3.2 WETLANDS COMMENTS AND RESPONSES

Figure 3.2-1a: Wetland Boundary - The Fairways
 Gateway Summit and The Fairways FGEIS
 Town of Carmel, Putnam County, New York
 Source: Insite Engineering, Surveying &
 Landscape Architecture, P.C.
 Date: 10/14/05
 Scale: Graphic

Figure 3.2-2: Updated NYSDEC Wetland Mapping Gateway Summit and The Fairways FGEIS
 Town of Carmel, Putnam County, New York
 Source: New York State DEC
 Scale: NTS

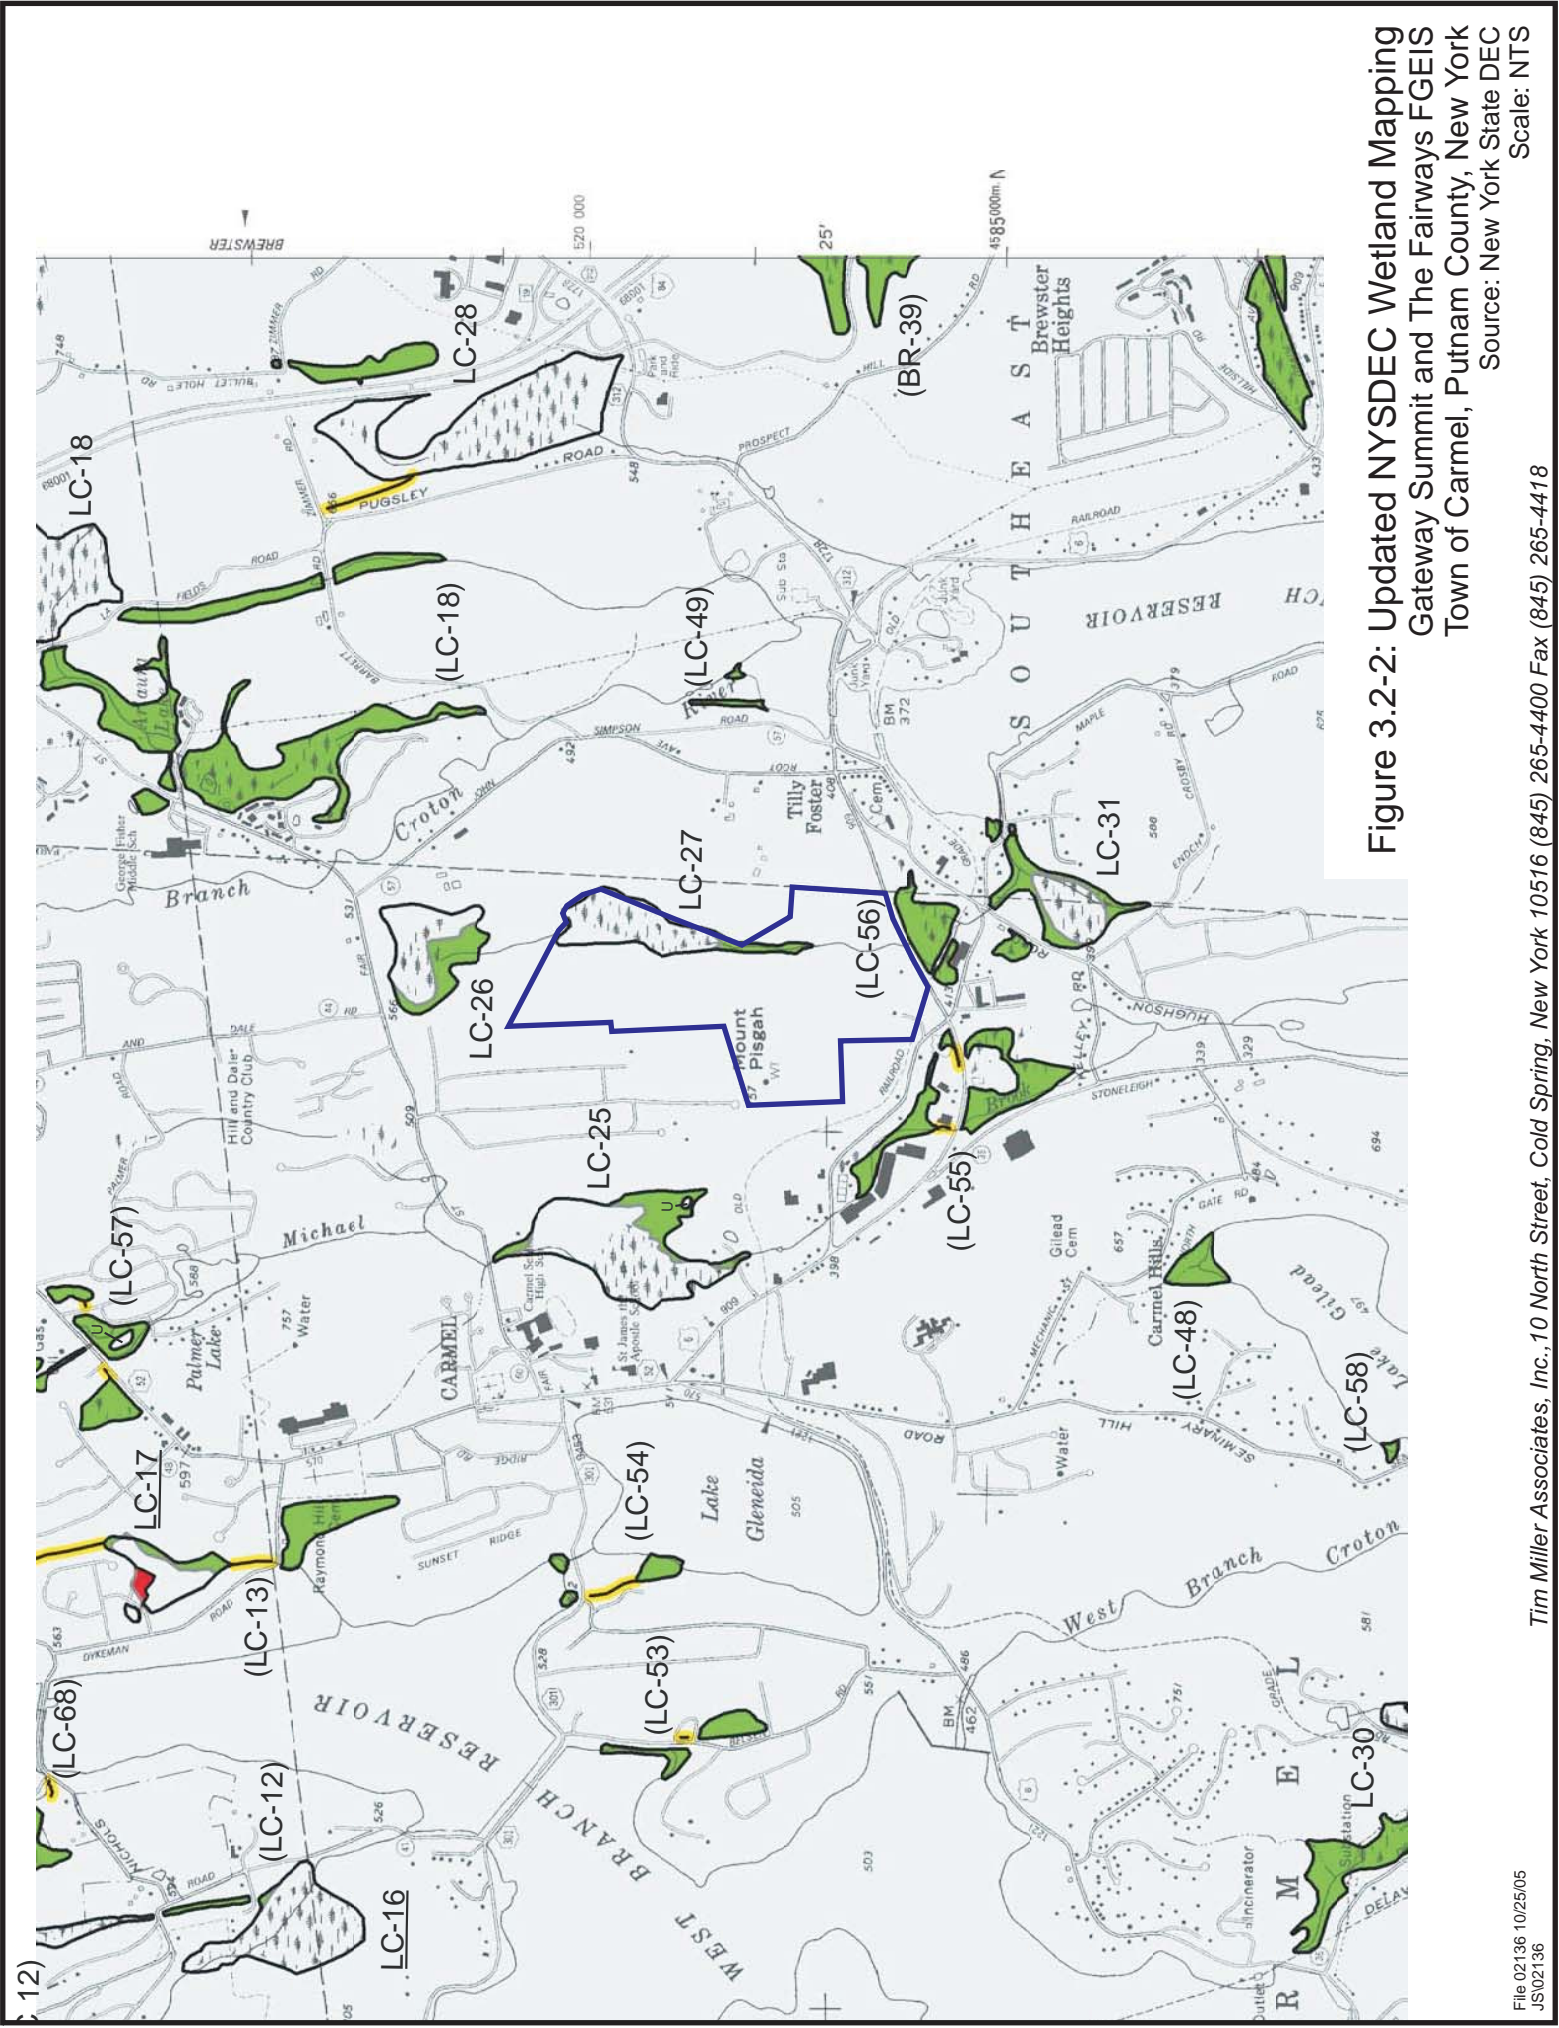
Comment 3.2-3 (Letter, March 4, 2005, James Benson, New York City Department of Environmental Protection): Appendix N discusses a small wetland on the Gateway Summit site referred to as the ECB wetland. It is unclear whether this wetland is the same wetland identified elsewhere in the DGEIS as federally or Town regulated. Appendix N also states that land investigated to the north and south of wetland ECB is not suitable for possible wetland creation areas because they are also wetland areas. The Applicant should clarify in the Final Generic Environmental Impact Statement ("FGEIS") whether the areas previously mentioned as adjacent to wetland ECB are contiguous with this wetland.

Response 3.2-3: *The Applicant has revisited the wetland delineation, and following consultation with the Town and the NYSDEC, has revised the wetland boundary on the FGEIS plans. The wetland corridor associated with the watercourse flowing from north to south in the eastern part of the property is now recognized as an extension of NYSDEC Wetland LC-27. With the exception of one area at the southern end of the wetland, the wetland boundary for both the NYSDEC and the Town of Carmel are the same. At the southern end of the wetland, the Town boundary extends slightly further south than the line flagged by the NYSDEC. These wetlands are now shown on Figures 3.2-1a and 3.2-1b. The revised NYSDEC wetland mapping generally showing this wetland extension is provided as Figure 3.2-2.*

Figure 3.7-1: The Fairways Utilities Plan
 Gateway Summit and The Fairways FGEIS
 Town of Carmel, Putnam County, New York
 Source: Insite Engineering, Surveying &
 Landscape Architecture, P.C.
 Date: 12/01/05, rev. 06/23/06
 Scale: Graphic

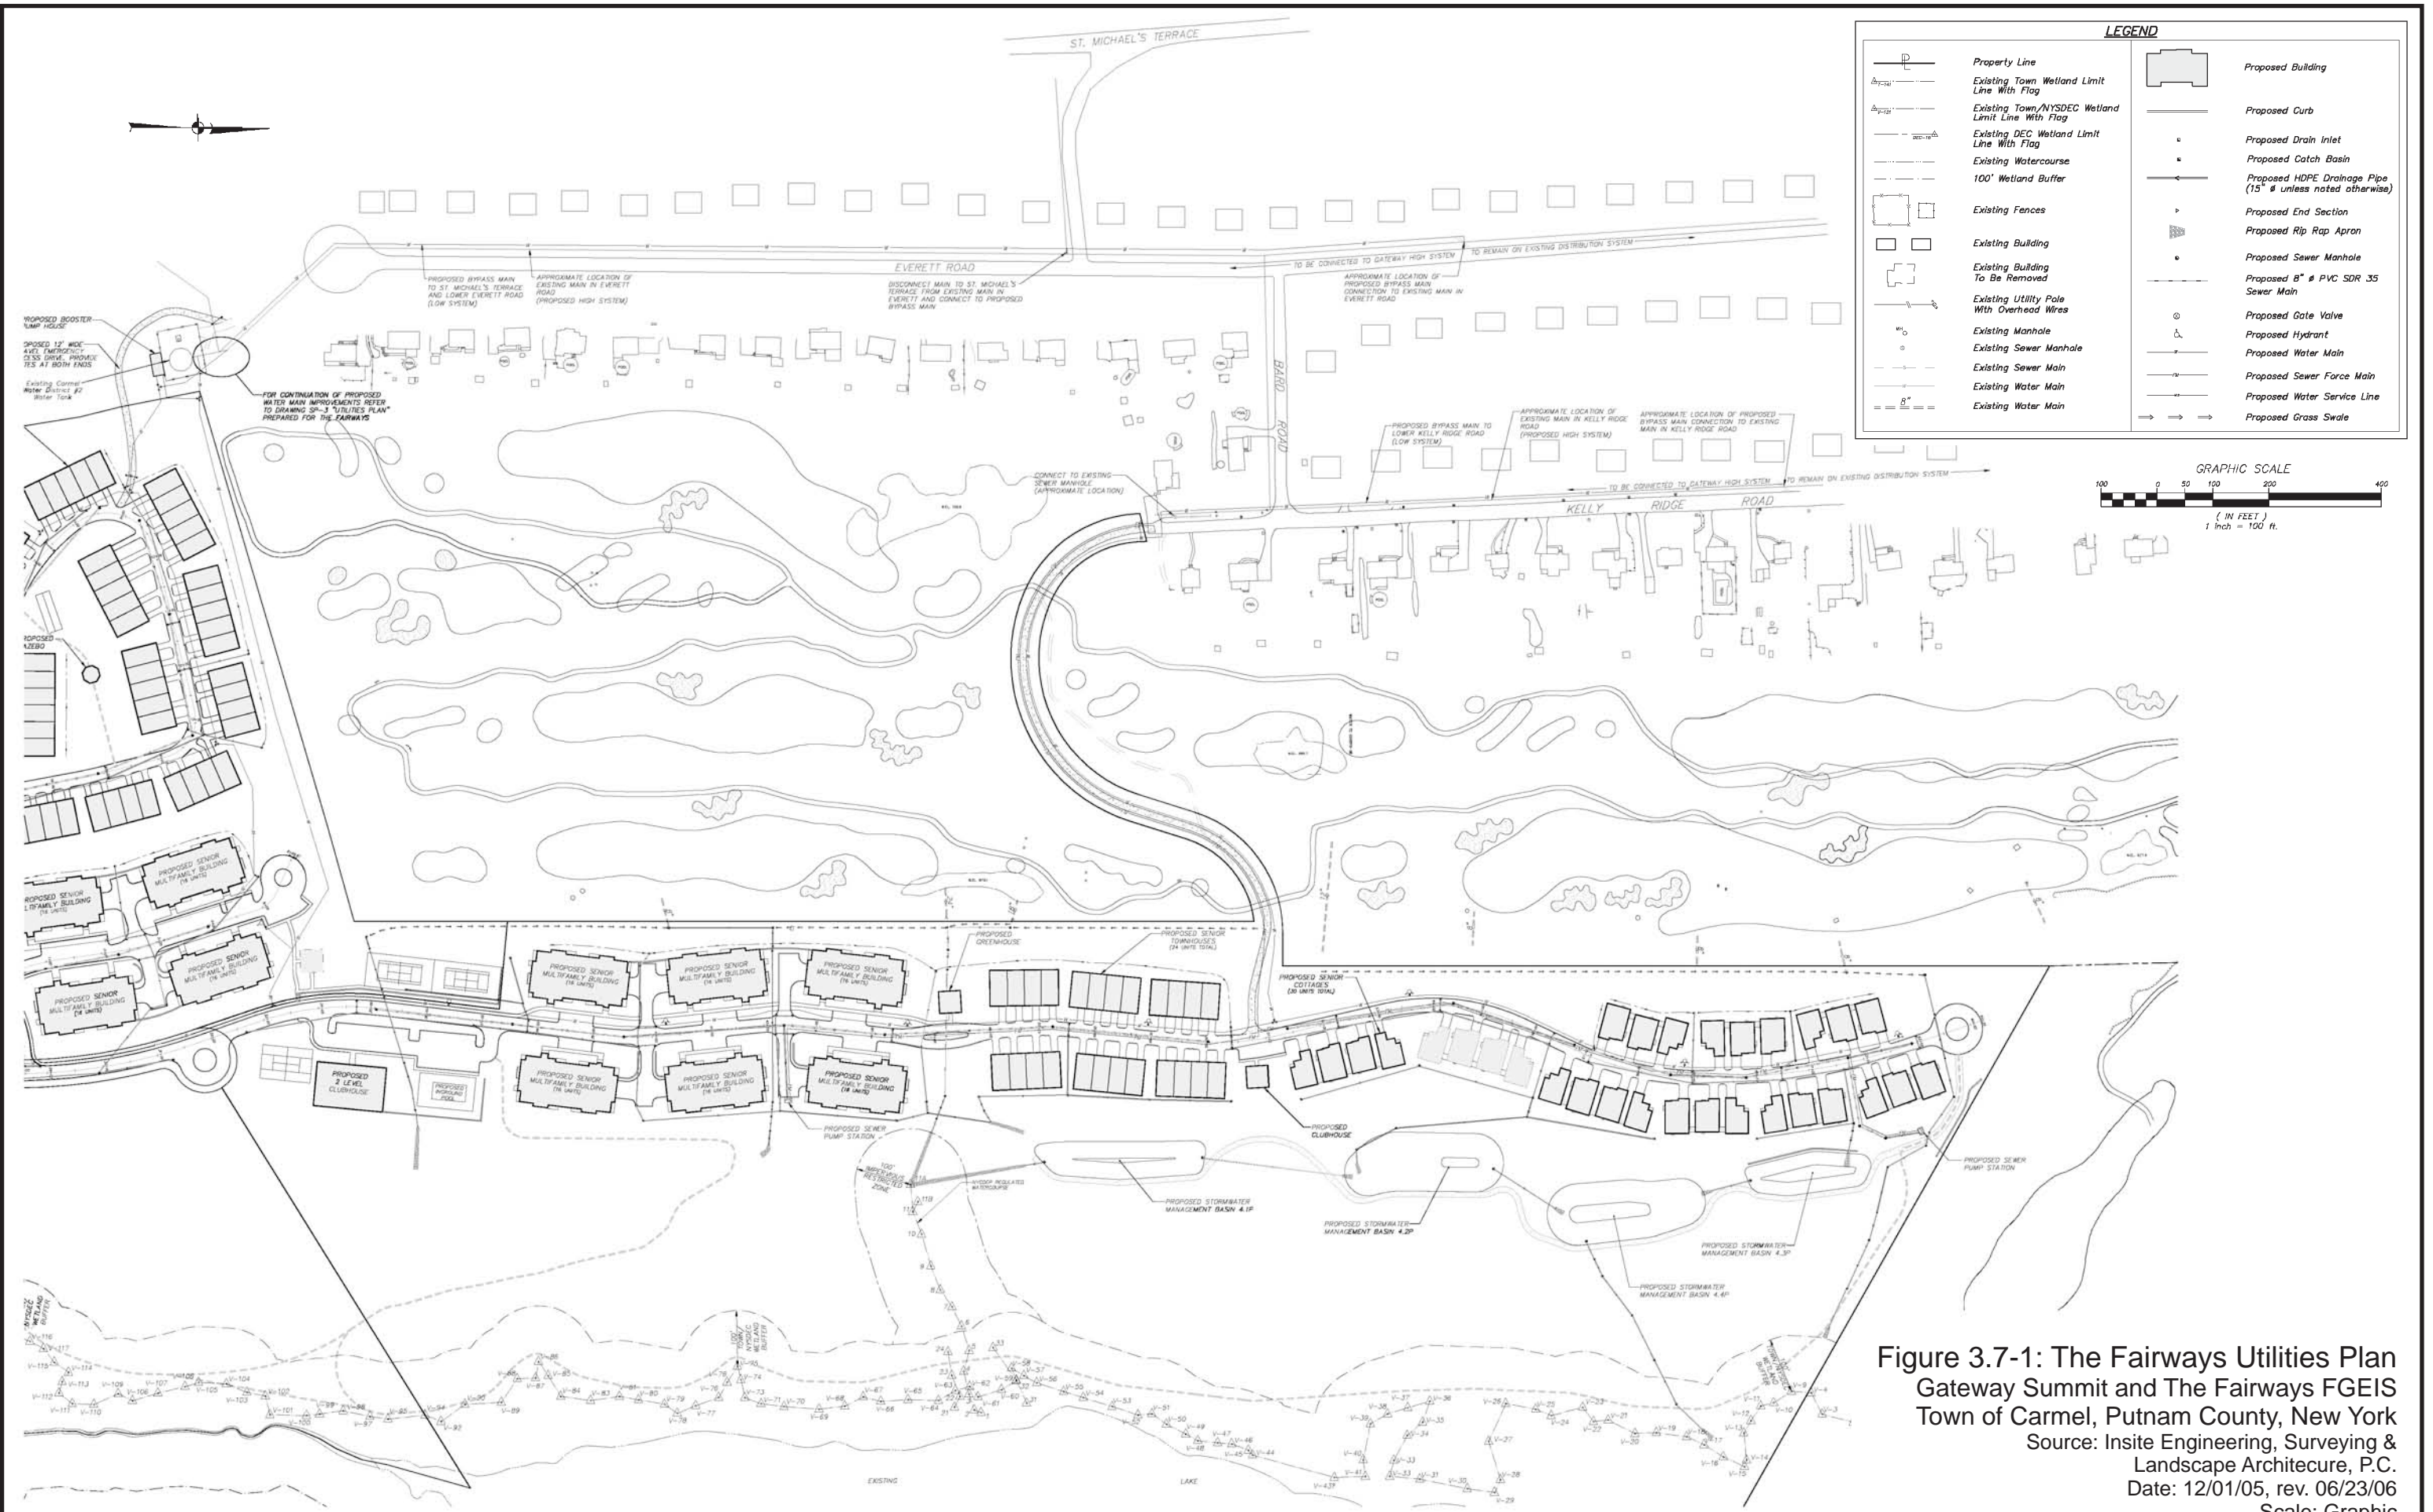
Comment 3.2-8 (Letter, March 4, 2005, James Benson, New York City Department of Environmental Protection): Scant detail is provided for the drainage diversion plan for the adjoining Centennial Golf Course. This needs to be integrated into the drainage analysis for the Fairways. Without this, a sound assessment of the potential impacts to receiving streams or wetland LC-27 cannot be made.

Response 3.2-8: *Information regarding the drainage diversion plan for the adjoining Centennial Golf Course is included on the utility plan prepared for The Fairways project (see Figure 3.7-1). Information has also been incorporated into the Fairways SWPPP found in the Appendix of this FGEIS.*

Figure 4-1: Restaurant and Office Alternative 1
 Gateway Summit and The Fairways FGEIS
 Town of Carmel, Putnam County, New York
 Source: Insite Engineering, Surveying & Landscape Architecture, P.C.
 Date: 04/11/06
 Scale: Graphic

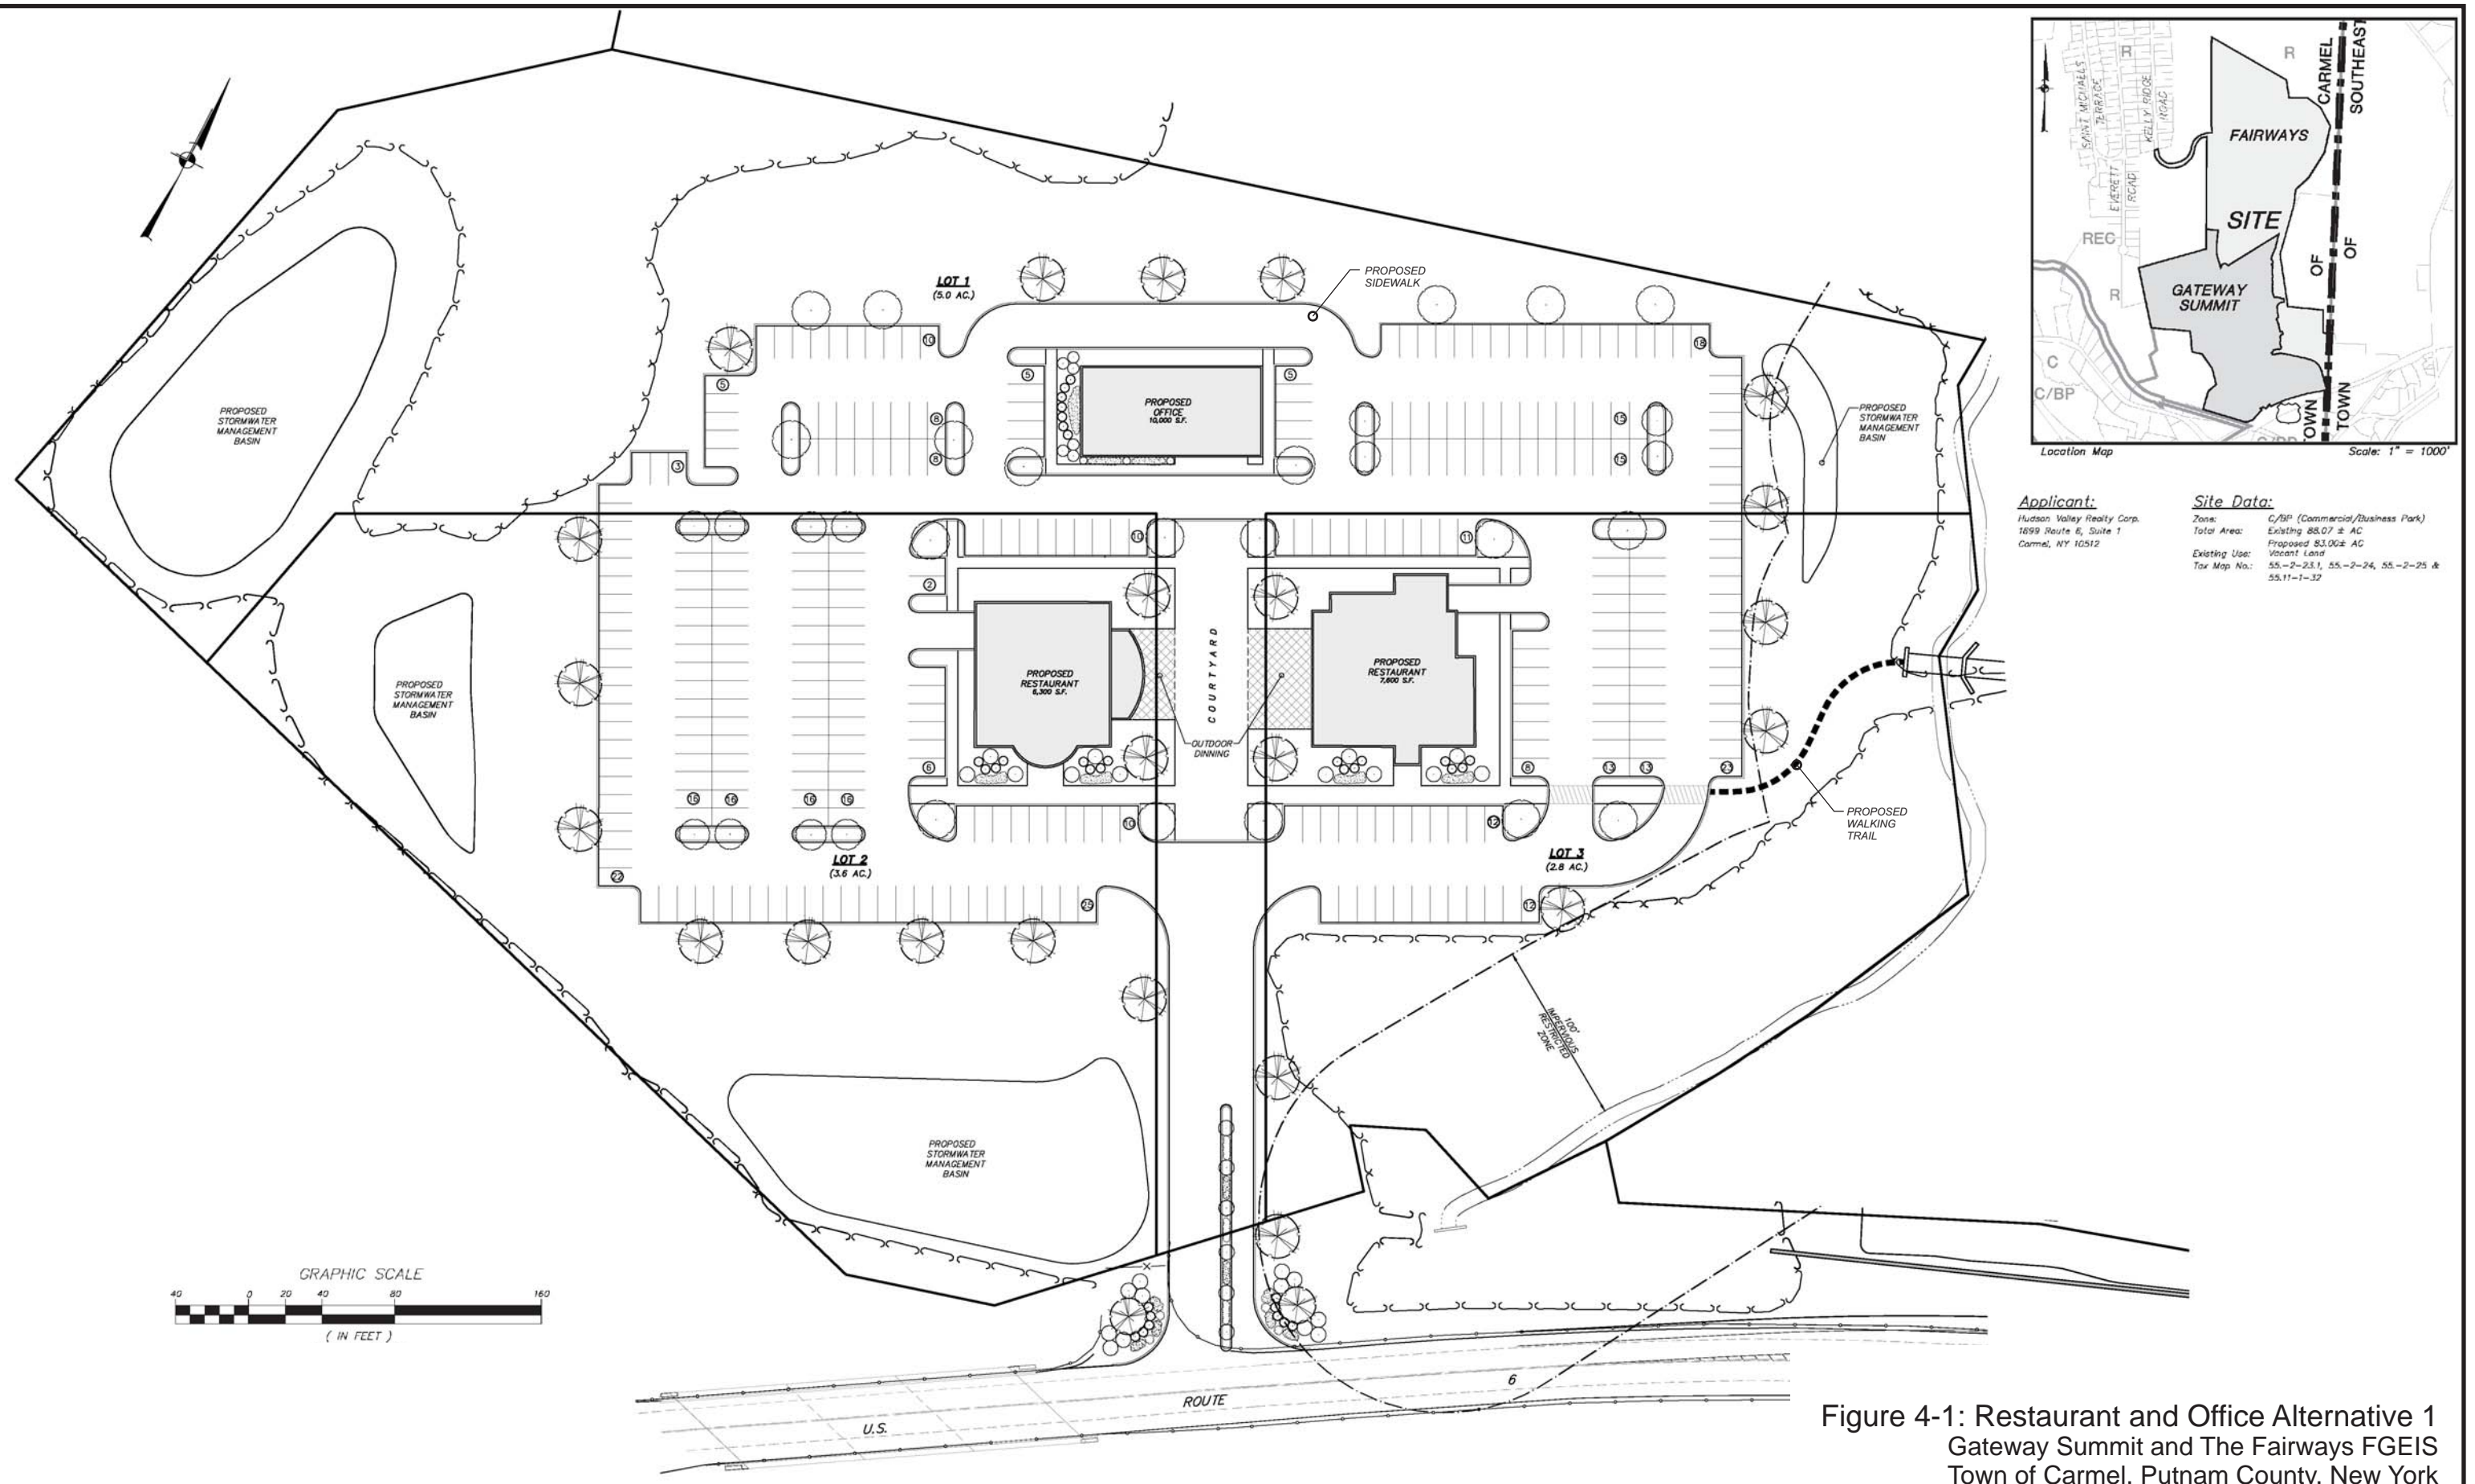
Comment 4-26 (Attorney General, Environmental Protection Bureau Letter, March 26, 2005): The applicant should focus on reducing impervious area by presenting alternatives in the DEIS that are designed to eliminate problems related to stormwater volume, including stacked parking and multi-story buildings.

Response 4-26: The Applicant has revised the plans for both Gateway Summit and The Fairways to include multi-family senior housing units that have parking located below the proposed buildings in order to limit the amount of impervious surface on the two sites. The amount of impervious surface has been reduced from 12.8 acres to 9.5 acres for The Fairways.
